ADDENDUM

STZC STAFF REPORT

FDP Modification: Symmes 95-1; Waterstone – Car Wash

For consideration by the Symmes Township Commission on June 15, 2022

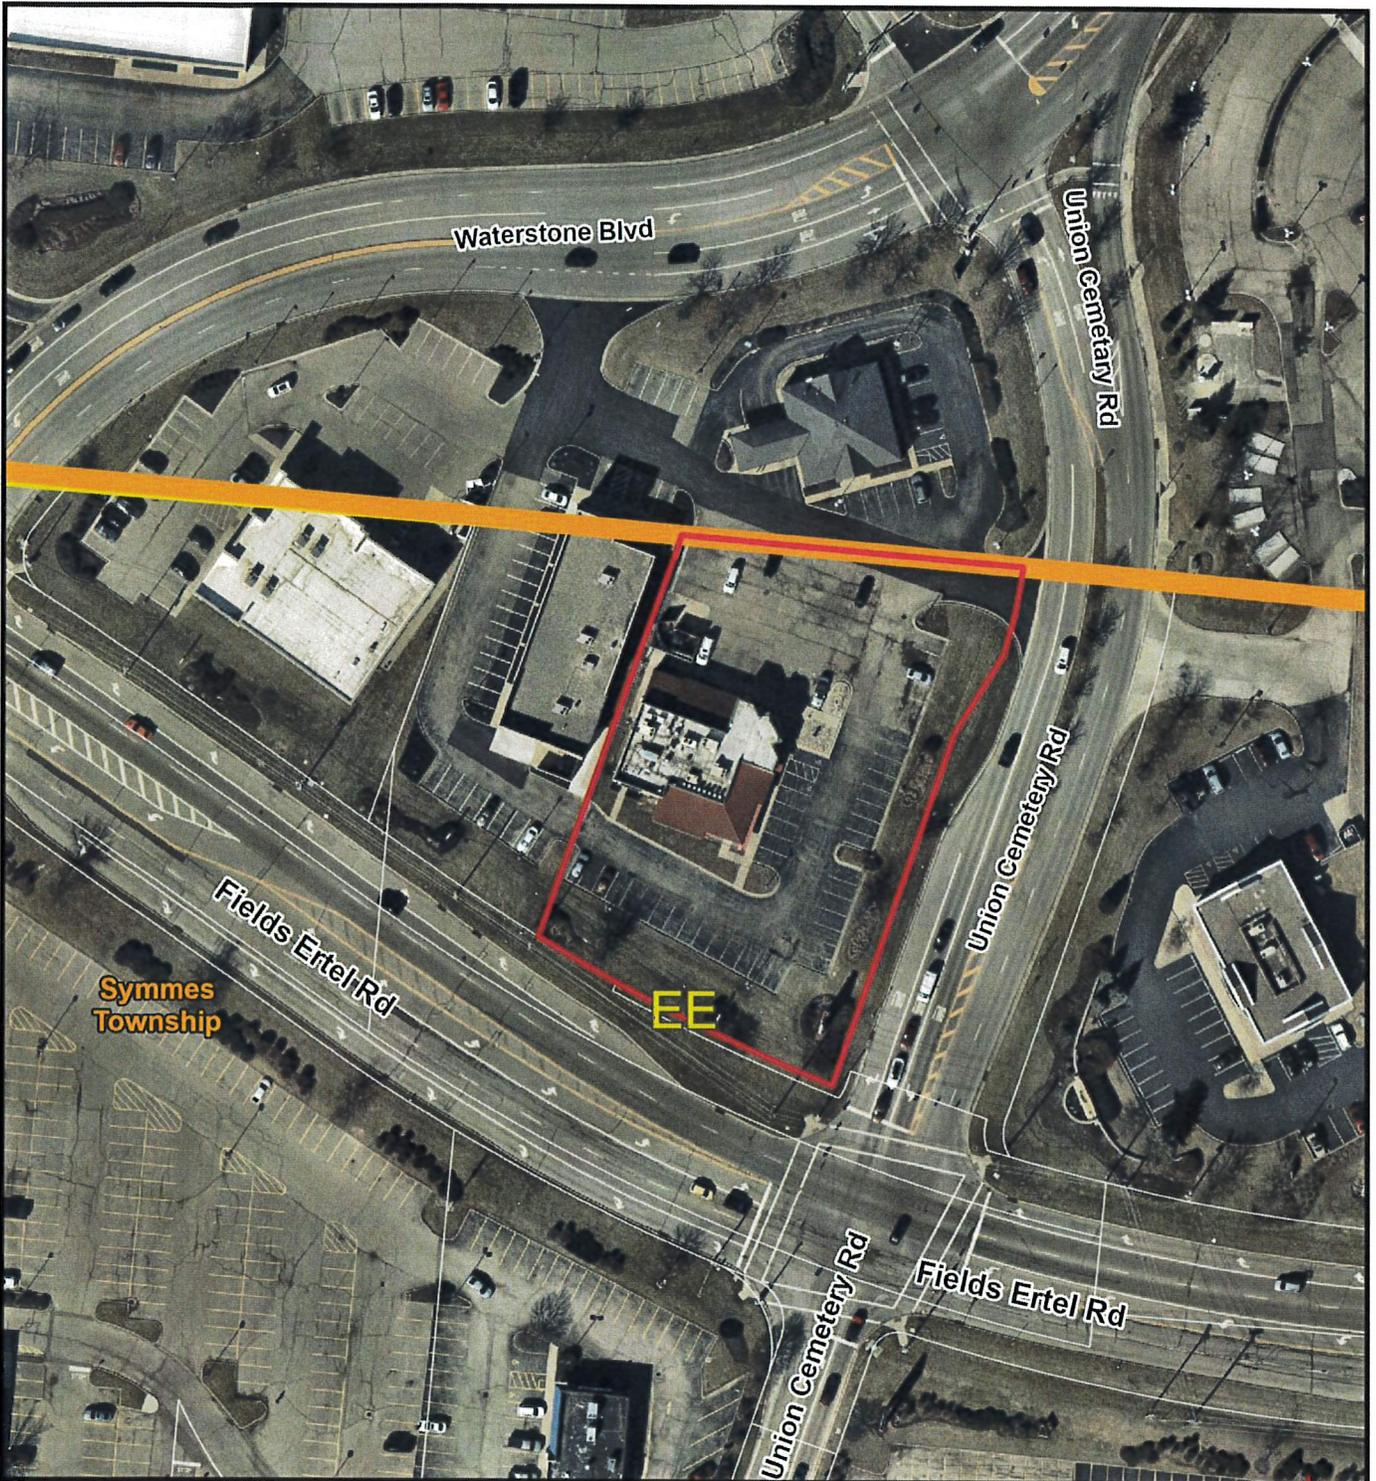
- The modified signage plan includes a monument sign detail illustration. This illustration and plan indicate compliance with the shape, size, and location of the approved sign policy. This illustration does include a blue background for the sign area, where the sign area is required to be PMS #3305 Green. However, it is noted that the illustration of the monument sign is for planning/illustrative purposes, and that final sign details will be completed by others in compliance with the policy. The Zoning Commission may consider requiring compliance with the policy be adhered to. Otherwise, the modified signage and elevation plans indicate signage that complies with the existing conditions and requirements of the Zoning Resolution.
